East Branch DuPage River Trail

Great Western Trail to Butterfield Road

Steering Committee

Meeting #2 Summary

Exhibit 1-2 Churchill Woods Alt. 1.2 Photos

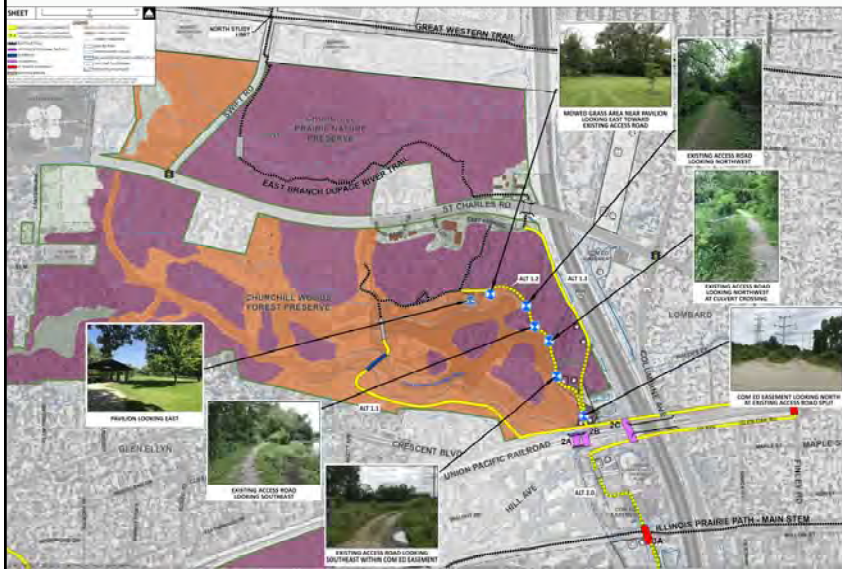
- Of the alternatives within Churchill Woods, the FPDDC supports Alt 1.2. Constructing a trail on new alignment through Class III or Class IV ecosystems is undesirable, and impacts should be avoided wherever possible. Alt. 1.1 and Alt 1.3 result in environmental impacts whereas Alt 1.2 would have relatively minimal environmental impacts and provides a good recreational benefit.

- ❑ Provided to FPDDC to show Class III and Class IV Ecosystem Impacts
- ❑ FPDDC staff indicated support for Alt. 1.2 through Churchill Woods

On the above basis, the group concurred with Alt 1.2 as the finalist alternative within Segment 1 to be carried forward into Phase I Engineering for further design development and evaluation.

Exhibit 1-4 Alt. 1.2 Cross Section

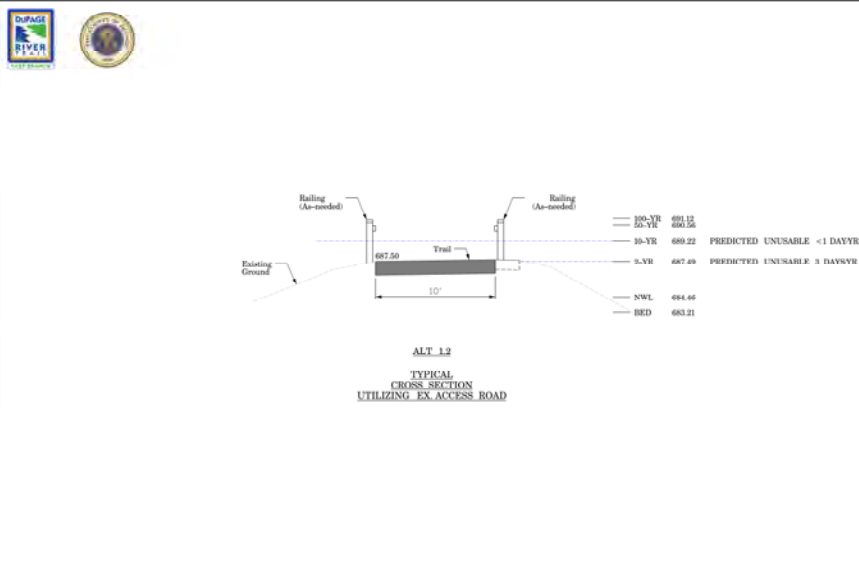
- Alt 1.2 was analyzed to have about a 2-year level of protection which would be usable for 362 days per year on average based on available stream gage data.

- Anticipated to be inundated 3 days/year on average per USGS Stream Gage historic data located at Butterfield Rd (see Exhibit 0 2)
- FPDDC staff recommended the trail to be asphalt in areas that may flood.

Exhibit 4-3 Crossing 4B Profile

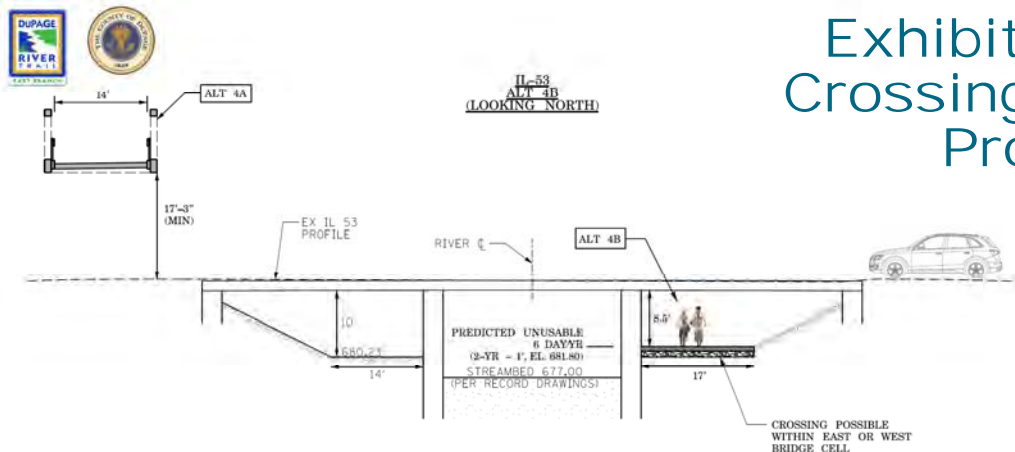
maximize the flood protection for Alt. 4B, the trail would be raised to provide 8.5' of vertical clearance. Based on available stream gage data, the trail is estimated to be inundated approximately 6 days per year. However, since raising the path fills the bridge opening area, it must be verified in Phase I Engineering to not obstruct EBDR flow. In addition, given the limited flexibility, more detailed EBDR stream analysis with updated Bulletin 70 rainfall data may further affect the feasibility of Alt. 4B.

- ❑ Per the IDOT bridge plans, the west and east cells of the IL 53 bridge over EBDP were built anticipating a future bike path. 10-ft clearance originally built is proposed to be reduced to a minimum 8-ft clearance to reduce the frequency of flooding.
- ❑ Anticipated to be inundated 6 day per year on average

On the above basis, the group concurred with Alt. 4A and Alt. 4B as the finalist alternatives at Crossing 4 to be carried forward into Phase I Engineering for further design development and evaluation.

Exhibit 5-3 Crossing 5B and 5C Profile

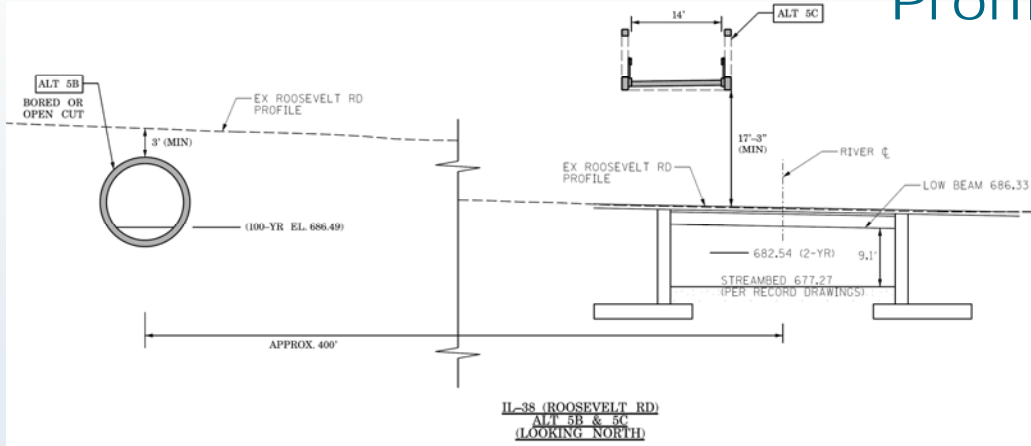
- It was shown at SC Meeting #1 that the existing Roosevelt Road (IL 38) EBDP hydraulic opening could not accommodate a trail. Alt. 5B is proposed as a standalone pedestrian underpass below Roosevelt Road (IL 38) that could be constructed above the 100-year floodplain elevation by taking advantage of the natural ground elevation increase going west of the EBDP.

- The Alt. 5C overpass is feasible on the west side of the EBDP away from the ComEd ROW and high-tension power lines. A consideration is its relative higher cost as compared to the other crossing alternatives. It was discussed that this bridge could also act as a decorative gateway portal for the Villages of Lombard and Glen Ellyn.

On the above basis, the group concurred with Alt. 5B and Alt. 5C as the finalist alternatives at Crossing 5 to be carried forward into Phase I Engineering for further design development and evaluation.
